MONTGOMERY COUNTY HISTORIC PRESERVATION COMMISSION
STAFF REPORT

| Address: | 24 Quincy St., Chevy Chase | Meeting Date: | 1/8/2025 |
| Applicant: | Holly Meers (David Easterday, Architect) | Public Notice: | 12/25/2024 |
| Proposal: | Partial Demolition and Construction of New Addition | | |

Figure 2: *The proposed addition will only be visible from a very limited angle.*

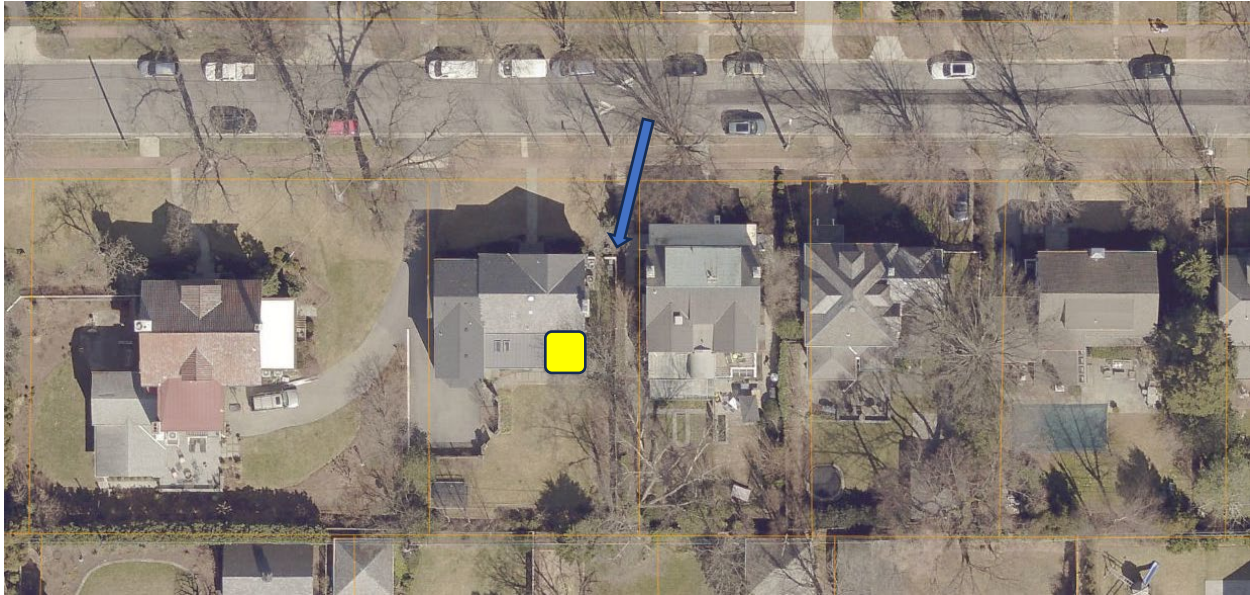
Staff finds the existing rear porch is not a historic feature that is not visible from the public right-of-way and its demolition will not negatively impact the character of the site or surrounding district. Staff finds the proposed addition and its associated chimney will be partially visible from an oblique angle along Quincy St. (see below). While visibility of a feature is a consideration, the larger factor is how that mass and scale of that feature affect the surrounding district. In this instance, Staff finds it will not impact the character of the district, largely because the proposed addition will be inset from the existing wall plane by 3' 7" (three feet, seven inches). Regardless of the addition's visibility, Staff finds its design is in keeping with the subject property's Colonial Revival architecture. Additionally, all of the materials

proposed for the addition are already present either in the original mass of the building or its later addition. Staff recommends the HPC approve the HAWP under 24A-8(b)(2) and (d) and *Standards 2, 9, and 10*.

1 Basement Existing/Demo Plan
 1/8" = 1'-0"

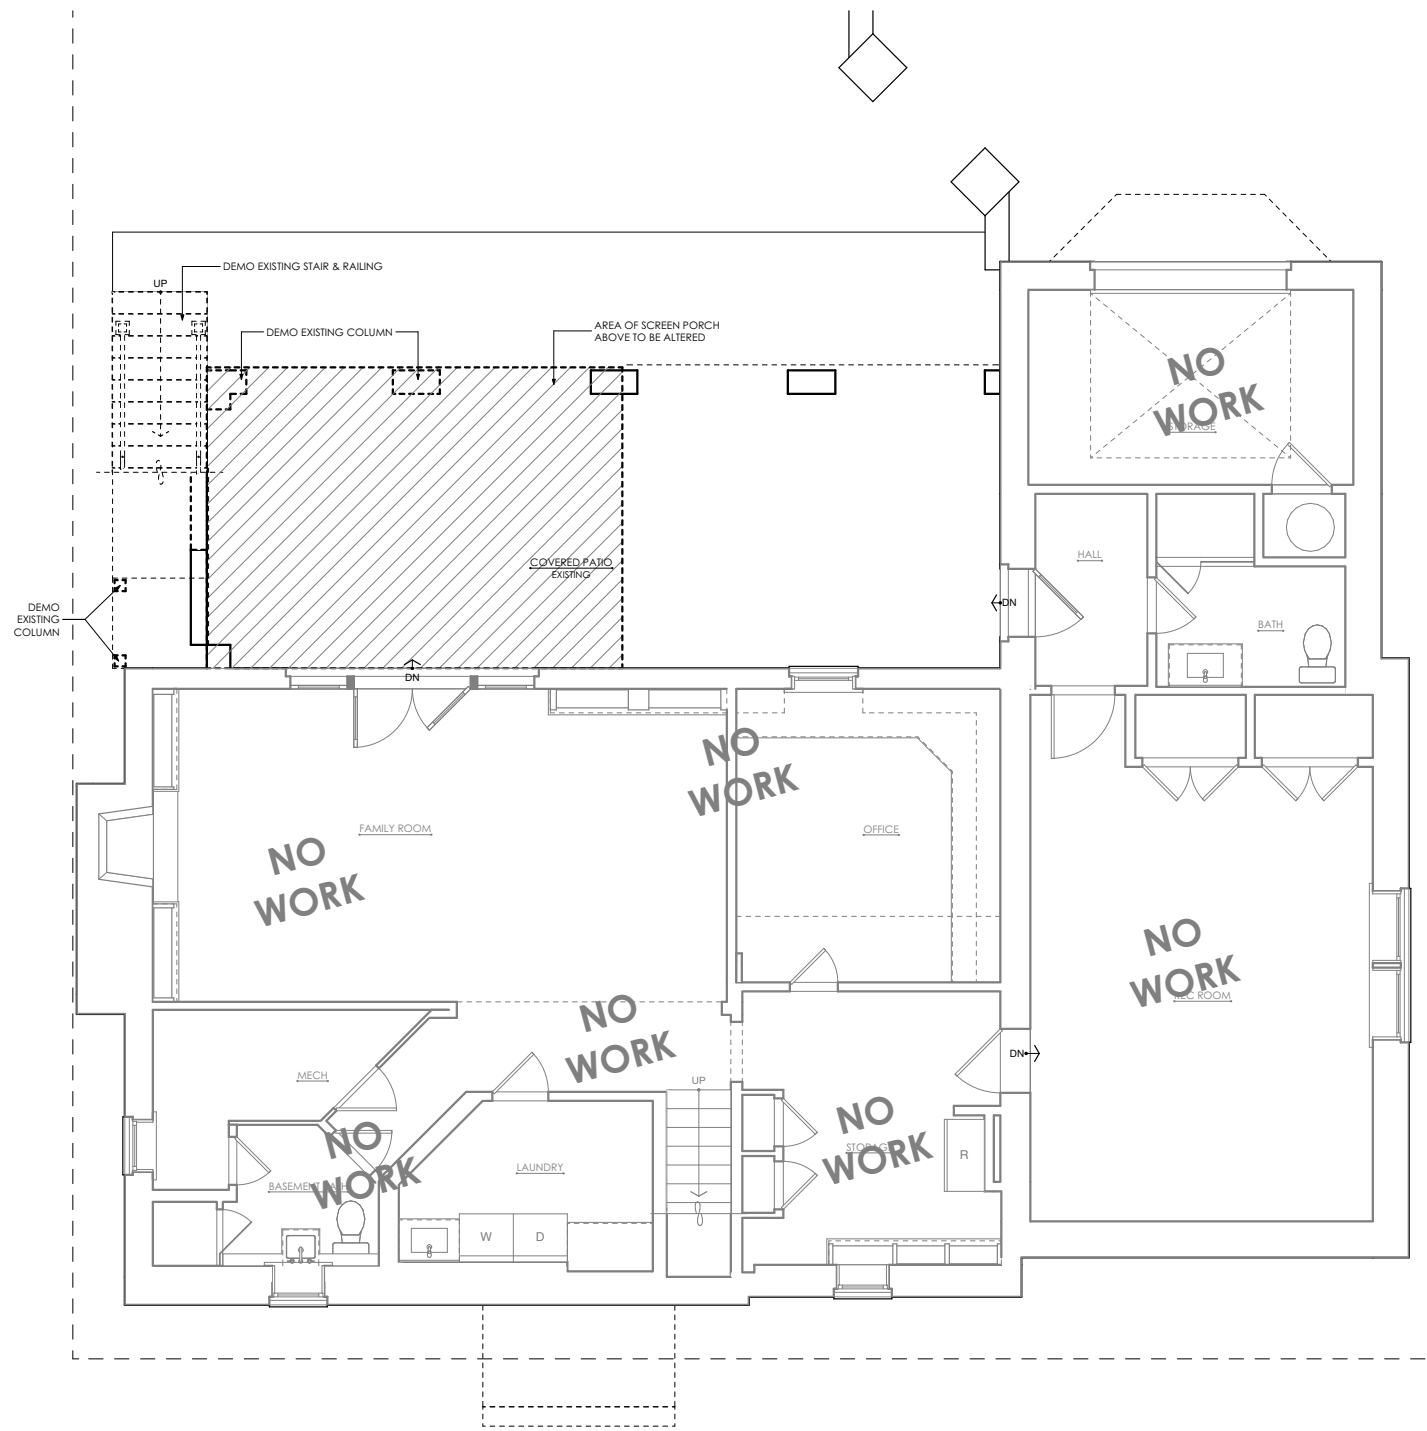
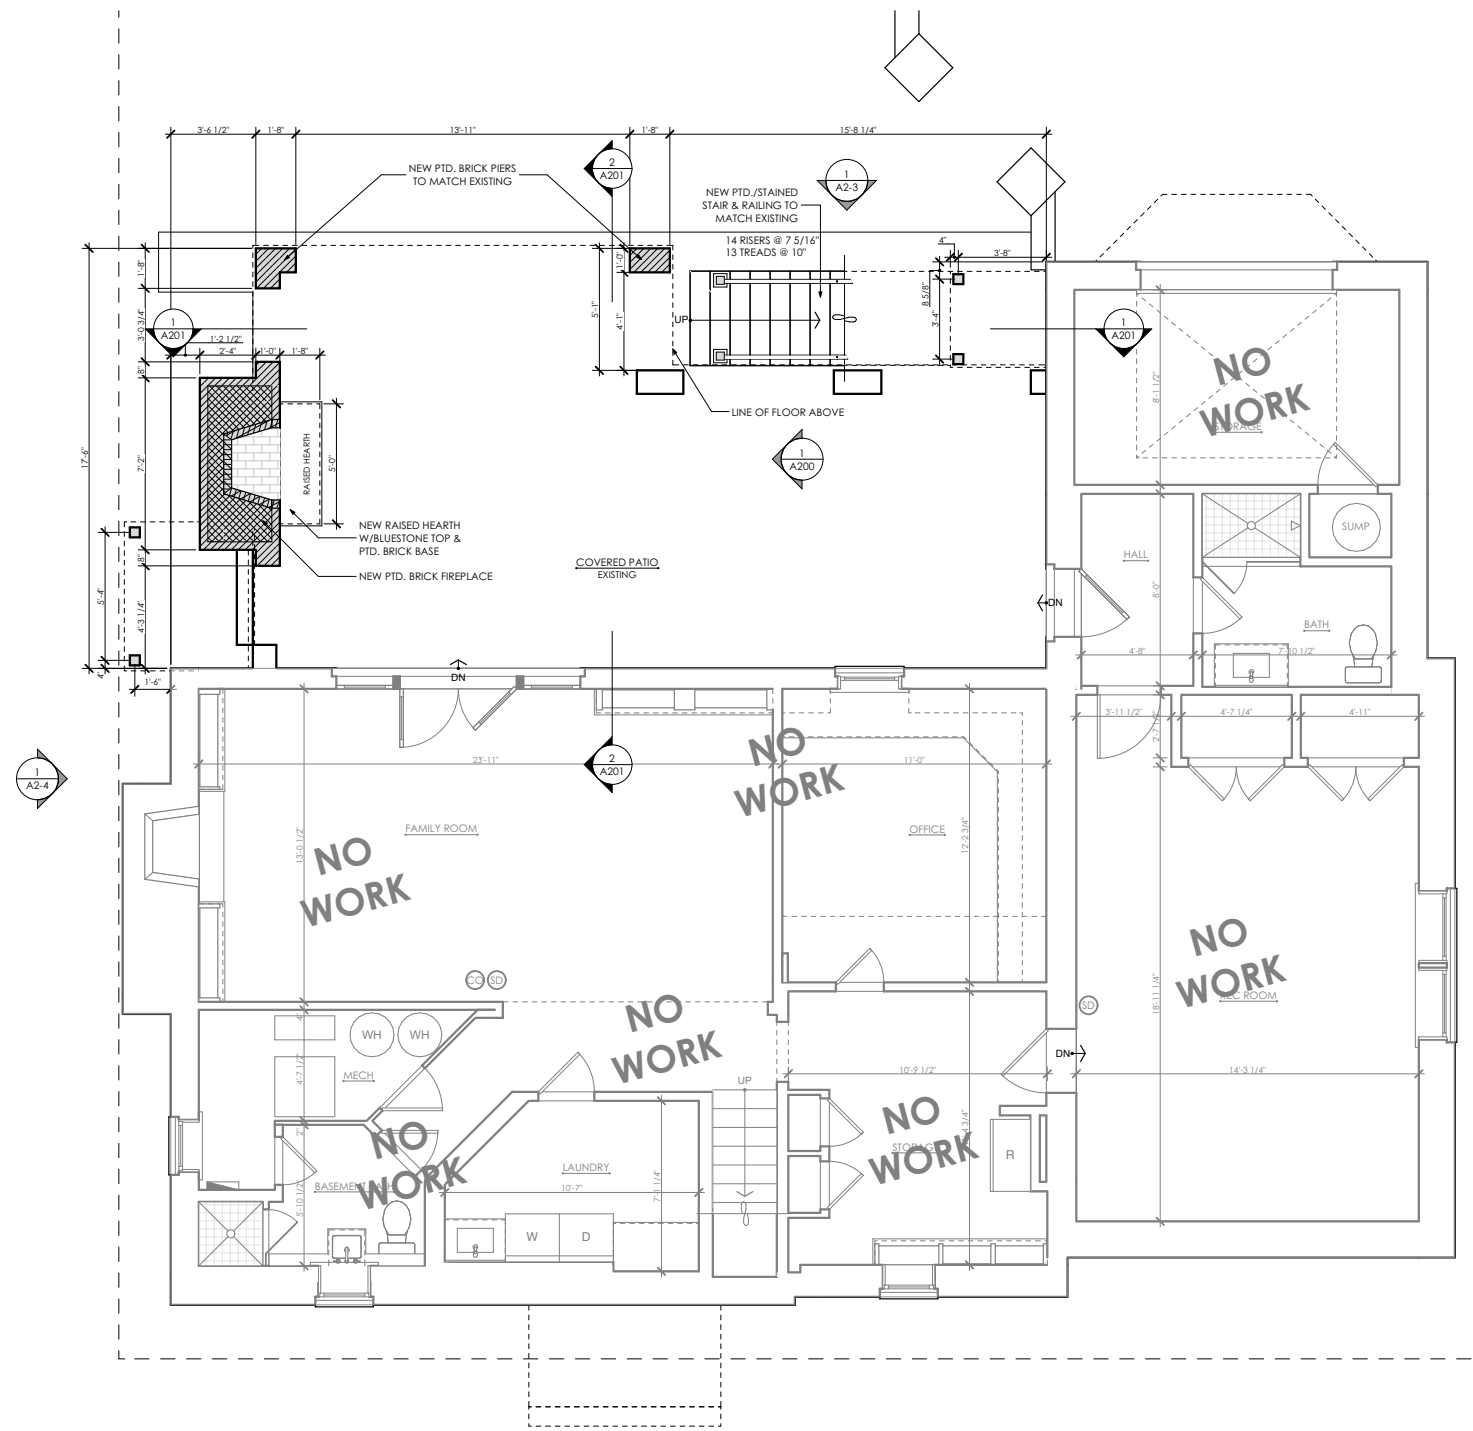
At the basement level, the applicant proposes to remove three of the brick piers that support the porch. Two of the piers will be reconstructed to support the new porch and addition above. The applicant proposes to eliminate the central painted brick pier.

Staff finds this feature only dates to 2014, so it is not historic. Additionally, as a basement feature on the rear of the house, it will not be at all visible from the public right-of-way. For these reasons, Staff finds that the brick pier removal should be approved as a matter of course per 24A-8(d) and the *Design Guidelines*.
